EVALUATION OF AMENDED RESPONSE TO CORRECTIVE ACTION REQUEST (CAR) YM-92-073  
RESULTING FROM YUCCA MOUNTAIN QUALITY ASSURANCE DIVISION (YMQAD) AUDIT  
YMP-92-22

8 CAR NO.: YM-92-073  
DATE: 09-03-92  
SHEET: 1 OF 1  
QA

CORRECTIVE ACTION REQUEST

RESPONSE TO ISSUANCE OF CORRECTIVE ACTION REQUEST (CAR) YM-092-073 RESULTING  
FROM YUCCA MOUNTAIN QUALITY ASSURANCE DIVISION AUDIT YMP-92-22 OF SANDIA  
NATIONAL LABORATORIES

FIGURE 1. RELATIONSHIP OF STRATIGRAPHY, LITHOLOGY  
AND HYDROSTRATIGRAPHIC ZONES AT G-4  
(Adapted from SNL [1991], Figure 3-5)

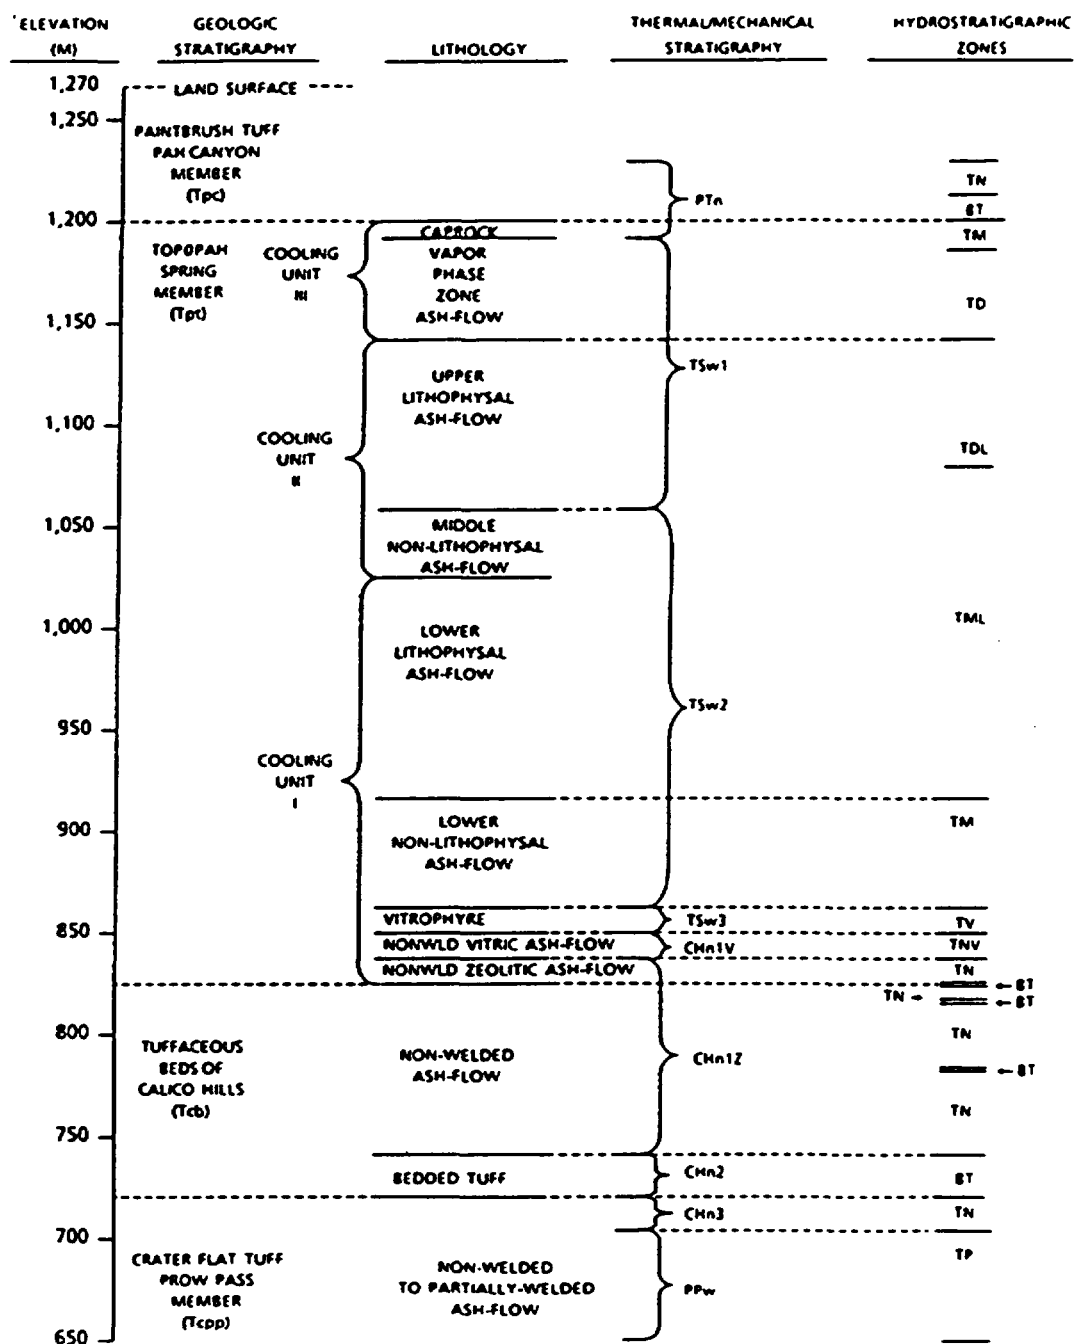
1 Controlling Document QARD, Revision 4		2 Related Report No. Audit YMP-92-22	
3 Responsible Organization YMP		4 Discussed With A. Simmons	
5 Requirement: The QARD, Revision 4, Appendix A, Paragraph 20.1.B.6 states planning measures include: "The evaluation of data quality to assure that generated data is valid, comparable, complete representative, precise and accurate."			
6 Adverse Condition: The Reference Information Base (RIB), Version 4, Revision 6, contains different values for Thermal/Mechanical Stratigraphy data for Borehole USW G-4. Stratigraphy depths found in Table 1 "Thermal/Mechanical Stratigraphy for Borehole USW G-4" (found in chapter 1, section 1, item 2, page 2 of 3) does not agree with the "Thermal/Mechanical Stratigraphy" values in Figure 1 "Relationship of Stratigraphy, Lithology and Hydrostatigraphic Zones at G-4" (found in chapter 1, section 4, item 4, page 3 of 6) in all cases.

Although no QA requirement has been breached, it is recognized that there is a potential for misuse of information presented in Figure 1 of Item 1.4.4. I appreciate the fact that the audit results pointed this out. Steps will be taken, in accordance with Yucca Mountain Site Characterization Project Administrative Procedure 5.3Q, to rectify the problem.

A. Remedial Action - Make corrections to data if necessary

B. Investigative Action - Perform technical review of data items 1.1.2 and 1.1.4 of RIB document

D. Corrective Action to Preclude Recurrence - Investigate AP 5.3Q for procedural clarity
